RECORD OF DECISION

Operable Unit One
New Cassel/Hicksville Ground Water Contamination Superfund Site
Towns of North Hempstead, Hempstead and Oyster Bay,
Nassau County New York

United States Environmental Protection Agency
Region 2
New York, New York
September 2013

DECLARATION FOR THE RECORD OF DECISION

FIGURE
2

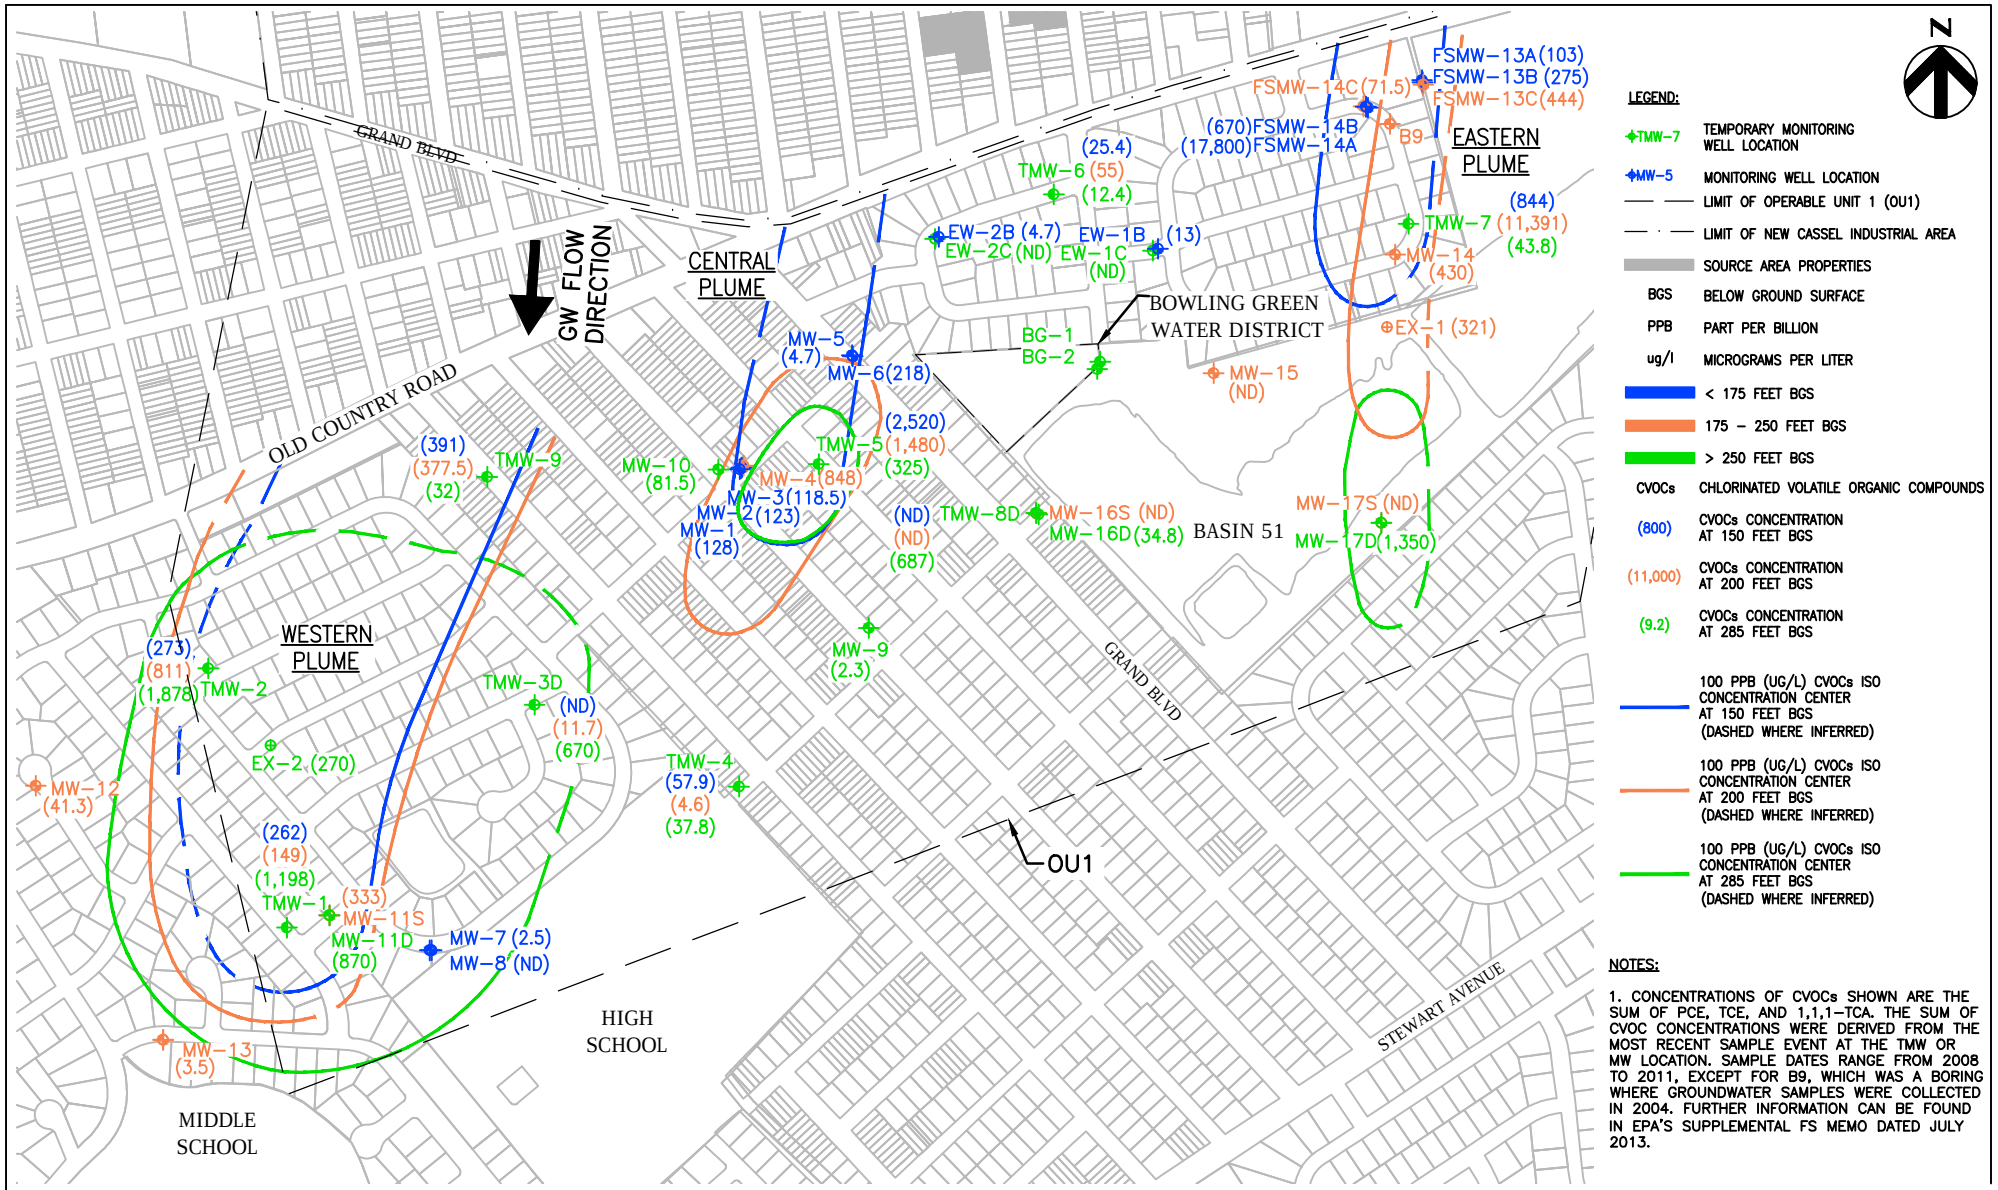
As seen in Figure 2 of the proposed plan, the OU1 western plume has contaminant concentrations greater than 100 μg/L and is therefore targeted for active remediation. Figure 2 depicts the current nature and extent of contamination and its intent was not to attribute source contribution of the contamination present within OU1.

Response to Comment # 24: As shown on Figure 2 of the proposed plan, in the eastern and western areas of OU1, the isoconcentration contours are in the downgradient boundaries of OU1. Therefore, those areas would require remediation. The isoconcentration contour depicts areas within OU1 greater than 100 μg/L of total chlorinated VOCs, as well as those areas where the EPA seeks to prevent the migration of the OU1 plumes.

FIGURE
3

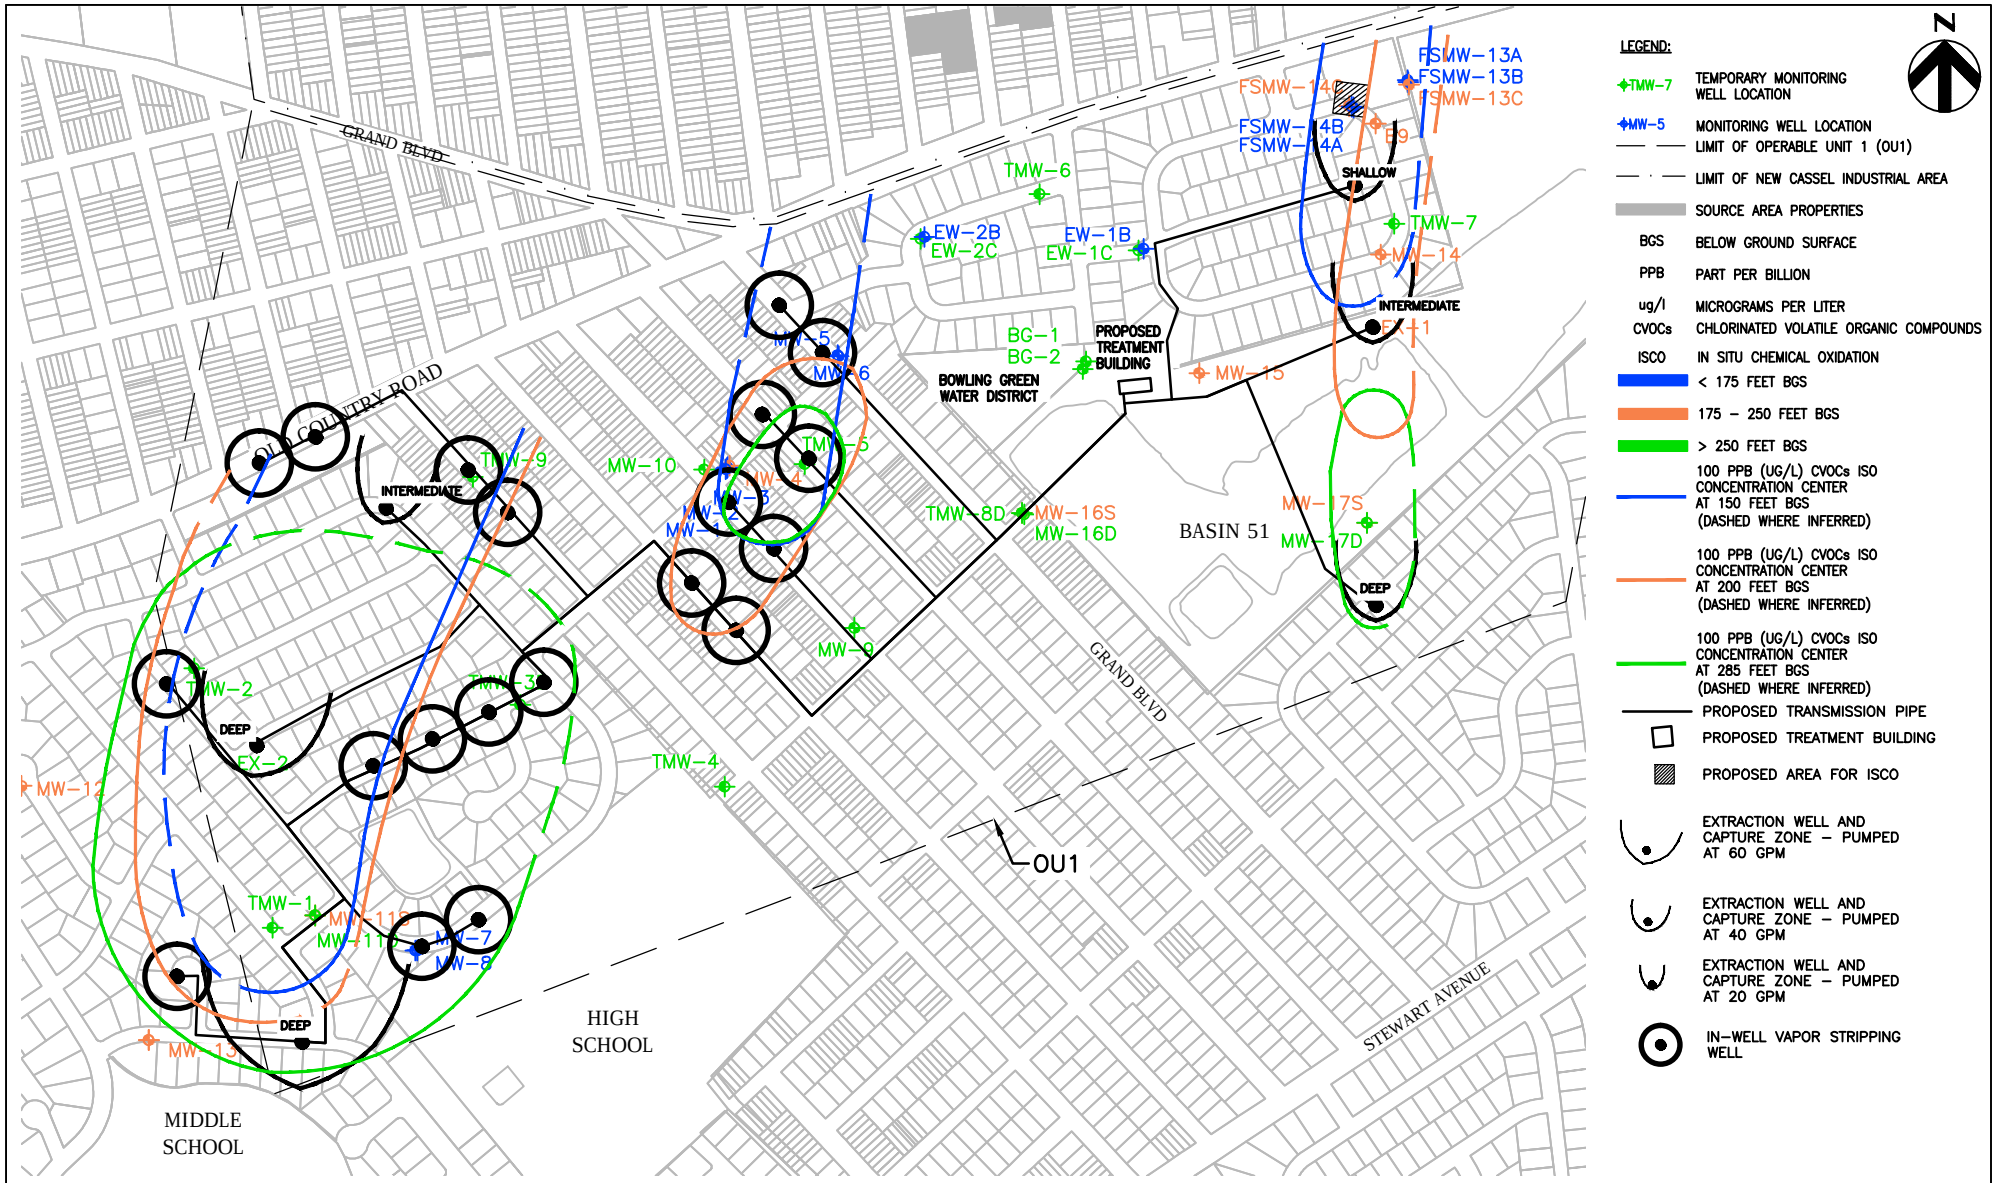
selected remedy is an aggressive and effective approach to restoring the aquifer that is consistent with the NCP. As shown in Figure 3, the selected remedy targets active remediation where concentrations of total chlorinated VOCs exceed 100 µg/L. The Bowling Green water supply wells are outside the footprint of the sidegradient and downgradient total chlorinated VOC plumes.

Response to Comment # 19: Figure 3 in the proposed plan depicts a conceptual design for Alternative 5, which is the preferred remedy. Placement of the remedial components of the preferred remedy in the conceptual design was based on estimated OU1 contaminant plumes that were developed based on the available groundwater samples and measurement results. Isoconcentration maps were prepared using measured groundwater elevations and regional groundwater flow. Groundwater sample results were used in conjunction with the groundwater flow direction across OU1 to develop the OU1 contaminant plume maps. The remedial systems including well locations were developed based on the estimated OU1 plume maps. Determinations, such as placement of extraction wells and/or in-well vapor stripping wells, will be finalized during the remedial design. As part of the remedial design, a pre-design investigation will be conducted and used to refine the layout of the remedial system.

FIGURE 2.1

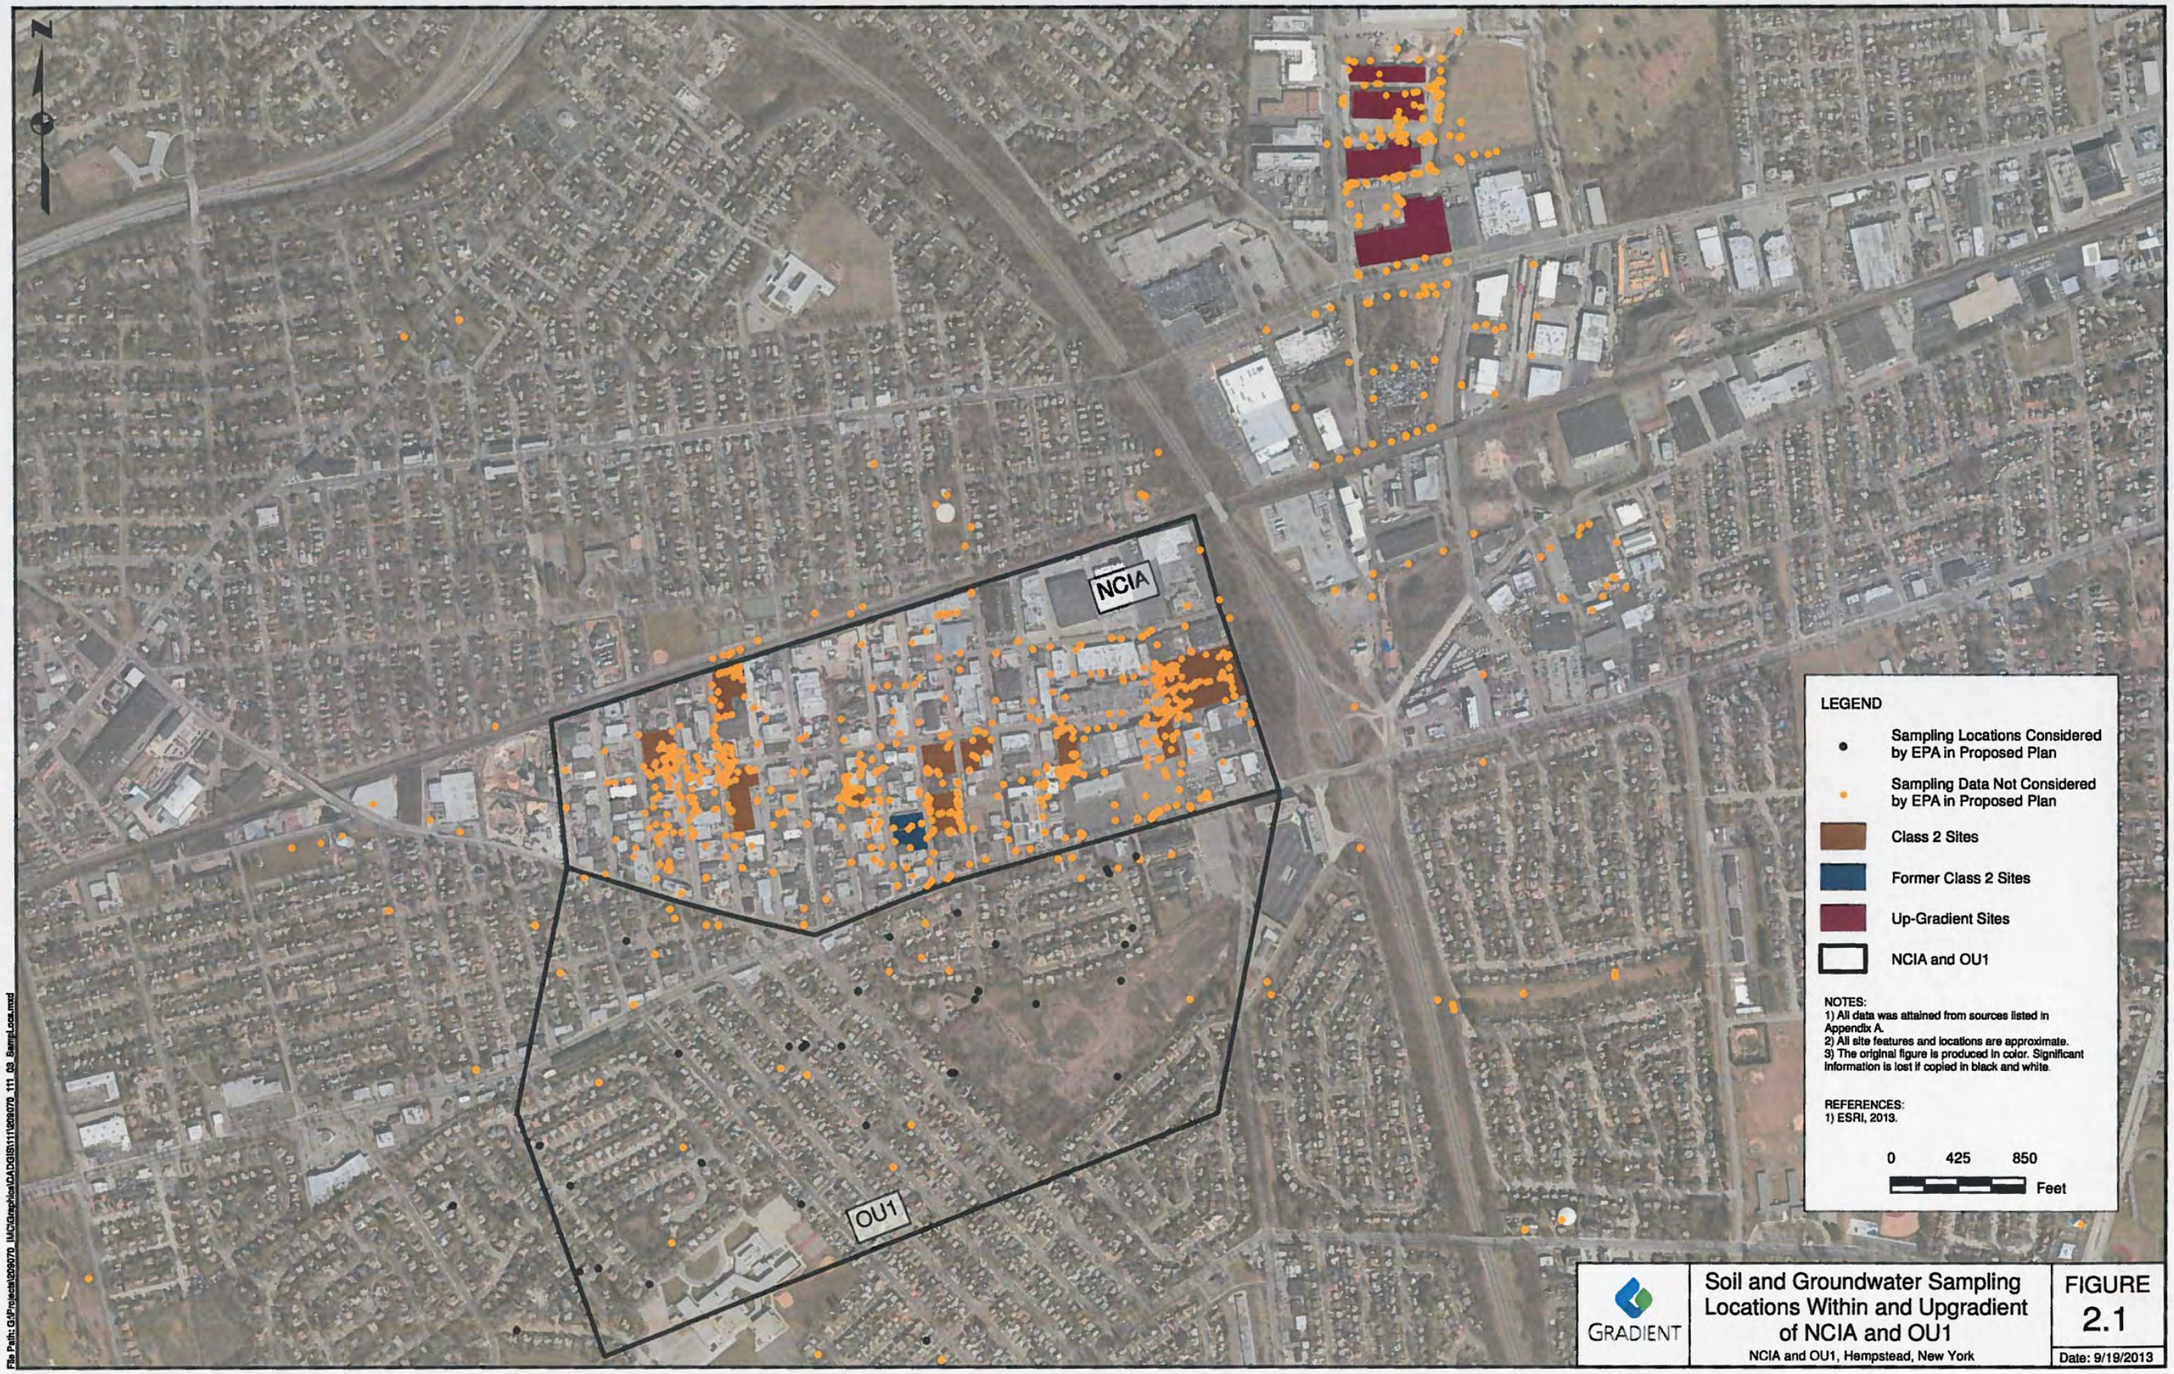
Appendix A lists all the studies that USEPA should have considered in the development of the CSM and the Proposed Plan. Despite the presence of a significant amount of data near and upgradient of OU1, USEPA has relied on a limited and unrepresentative dataset (see Section 2.4) in the development of its CSM for OU1 and the remedial actions specified in the Proposed Plan.[2] In summary, the data not considered by USEPA include, but are not limited to the following (Figure 2.1):
